Noise Feasibility Study

**Proposed Mixed-Use
Development
The Gateway Centre
Highway 124 & Poplar
Sideroad
Collingwood, Ontario**

July 7, 2025
HGC Project #: 02400511

APPENDIX D – Response to Comments

Figure 2 - Proposed Site Plan Showing Prediction Locations

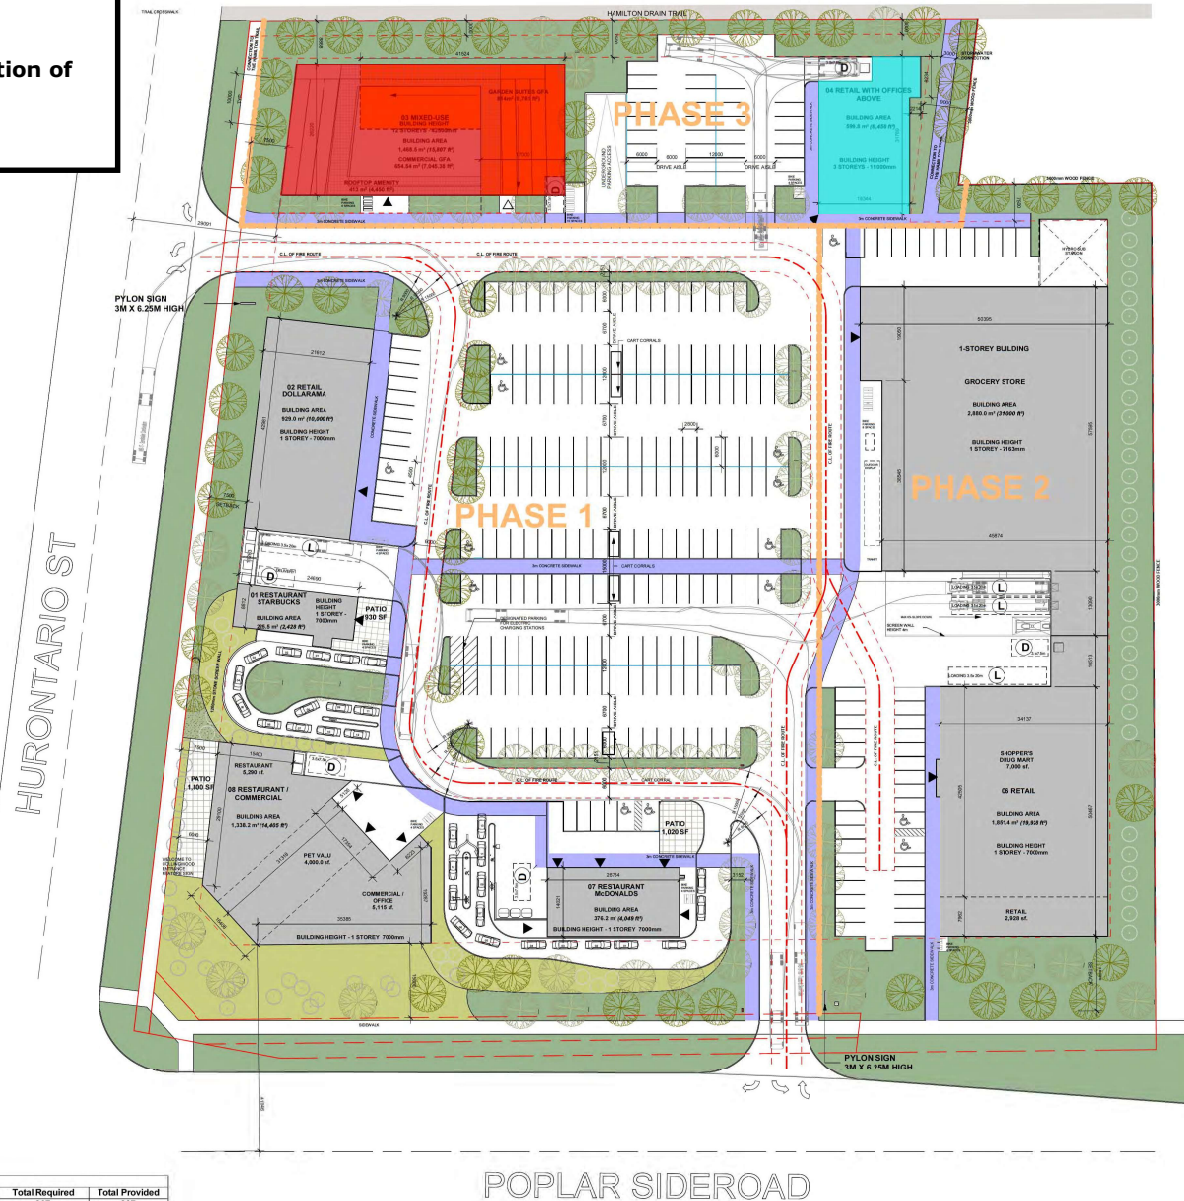
4. Figure 2 and the zoning map in Appendix 'A' have been 'cut off'. Please correct.

The figures in the revised report have been scaled to letter size.

Figure 5a - Maximum Predicted Daytime Sound Levels from Proposed Stationary Noise Sources On Existing Sensitive Uses (Without Mitigation)

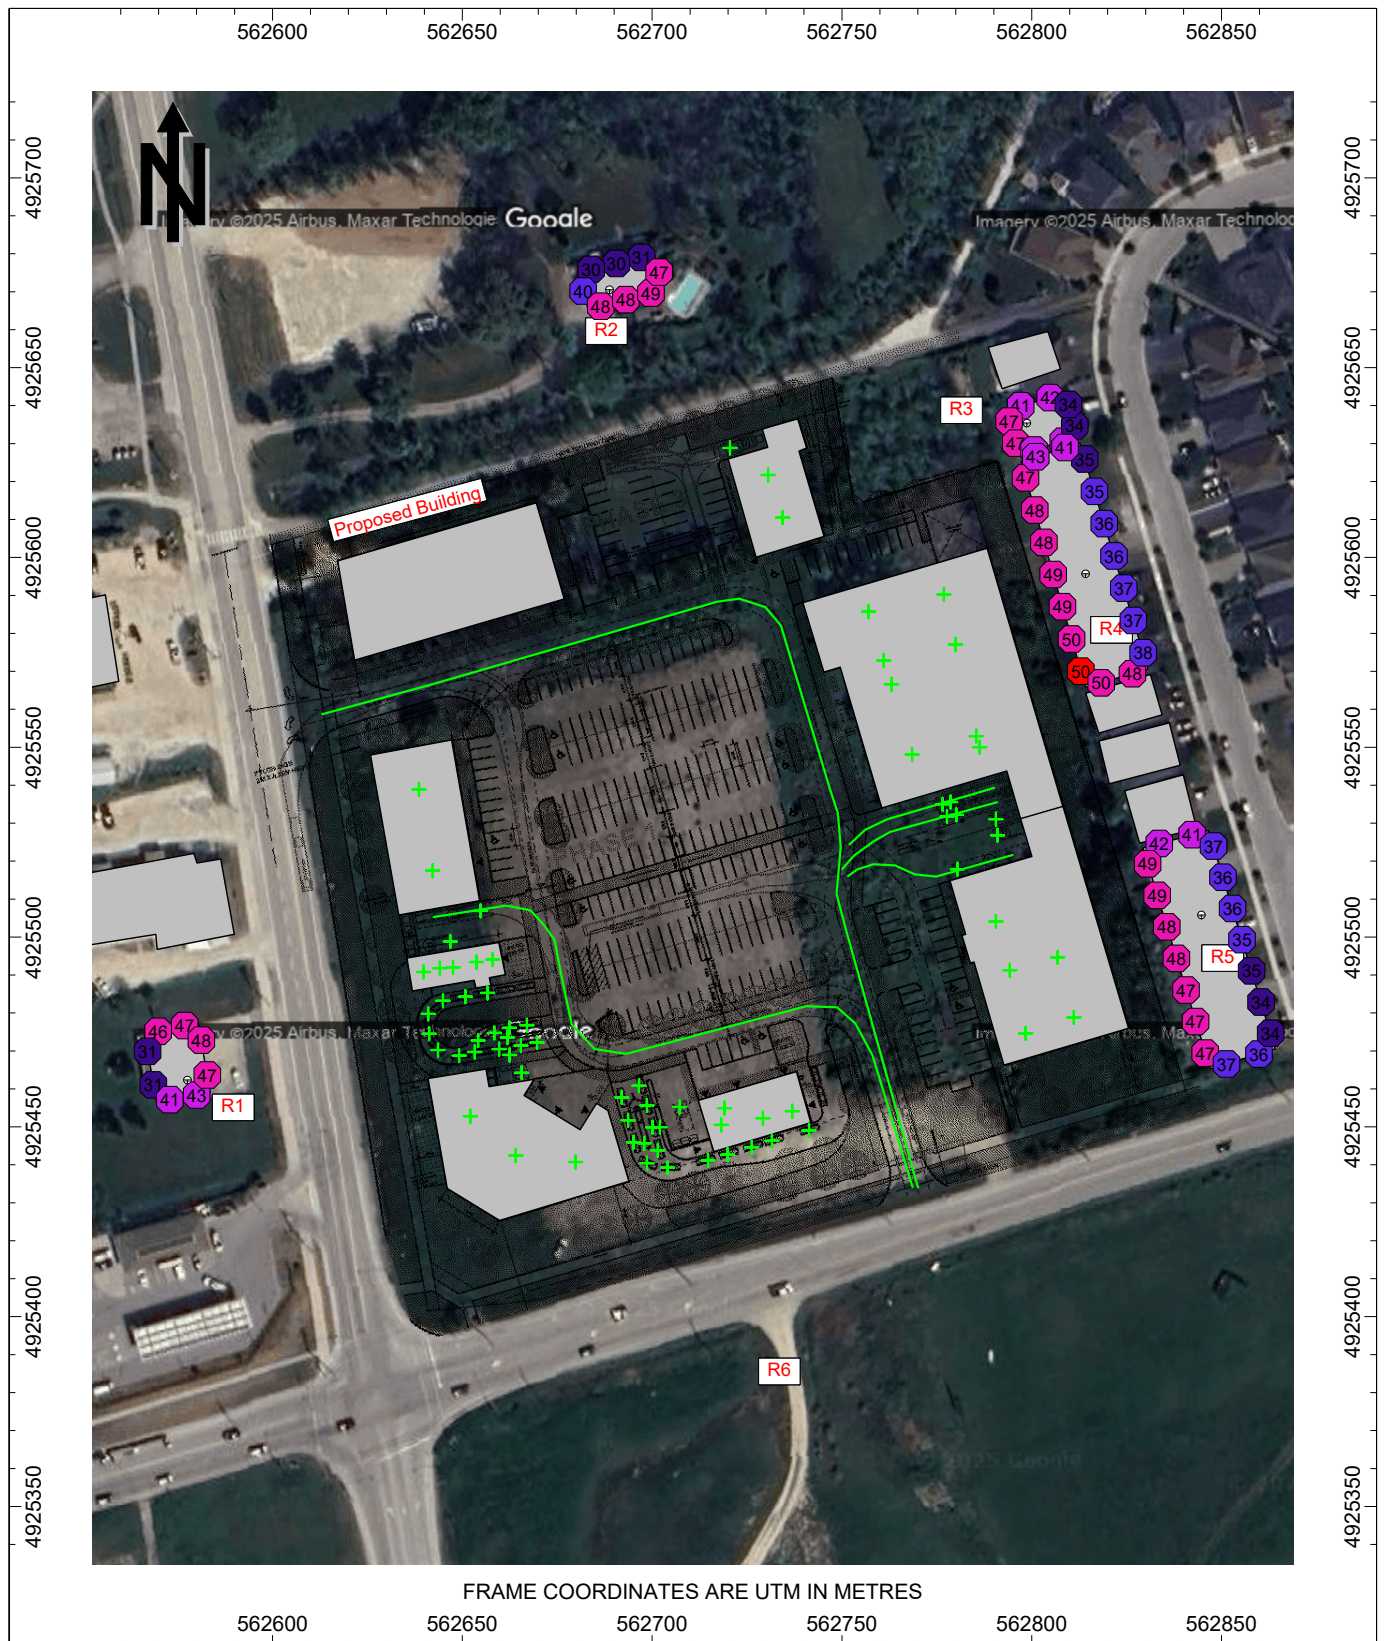
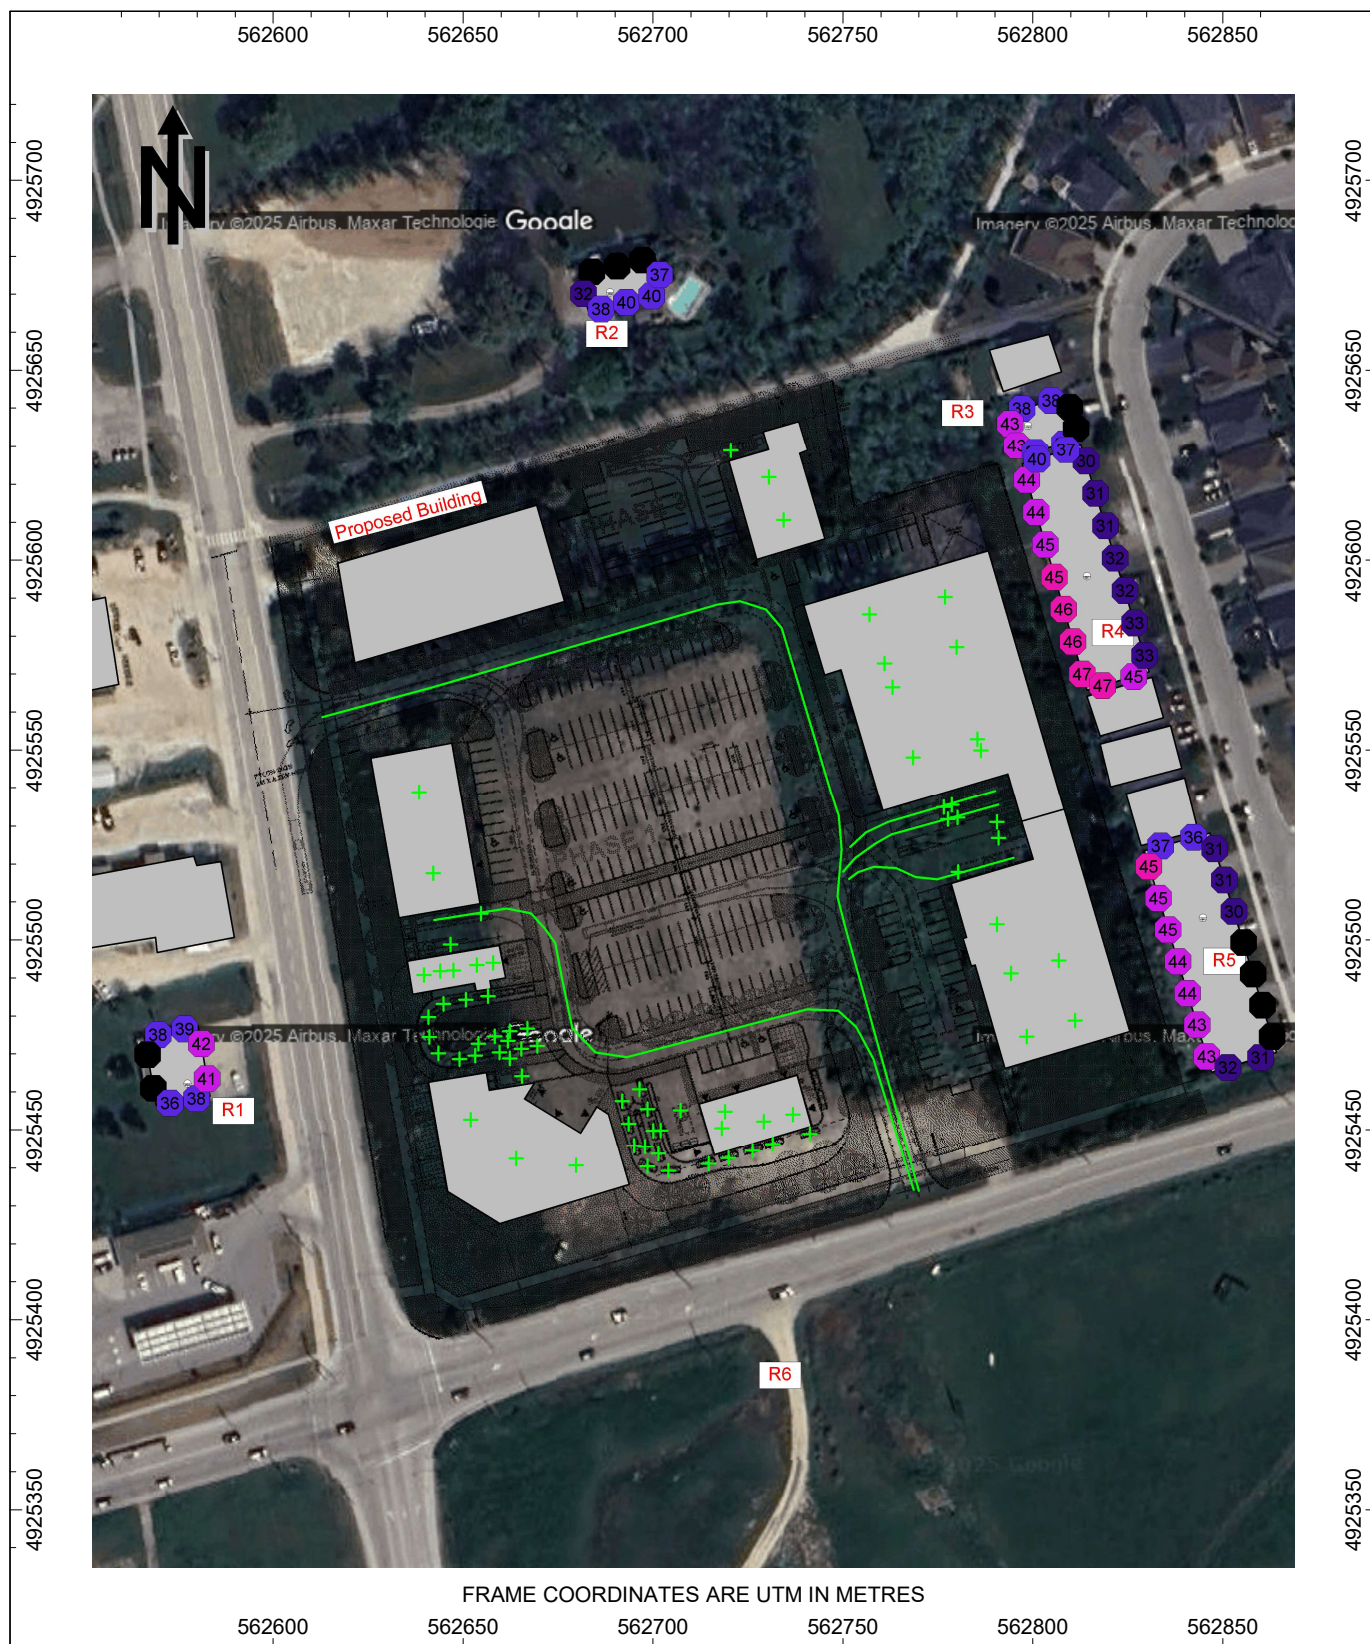
5. Please provide sample Cadna-A inputs/outputs to support the results shown in Table III and Figures 5a and 5b.

Sample Cadna-A inputs/outputs are provided in Appendix C of the revised report.
